Staff Report & Recommendations

La Center Middle School:

Type III Conditional Use, Site Plan, Variance and SEPA DNS

(2018-027 CUP) January 3, 2019

Figure 5 North Triangle Delineation

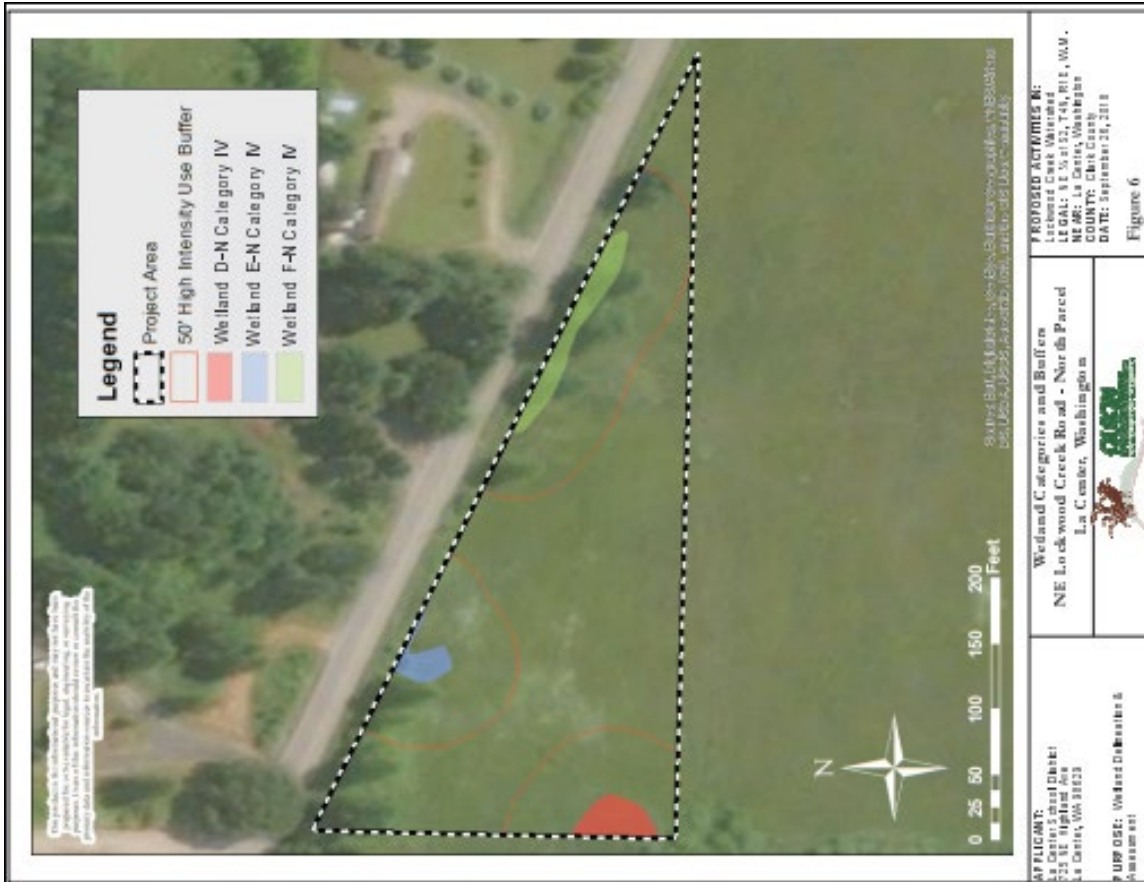
The Olson Environmental 2018 report for the North Triangle identified three wetlands – two along the site’s NE Lockwood Creek Road property line and one along the west property line in the north corner. The two wetlands along the street property line will be completely removed, along with their buffers. The wetland along the west property line will not be disturbed, but its buffer will have temporary disturbance during grading of the site for installation of the driveway and parking area.
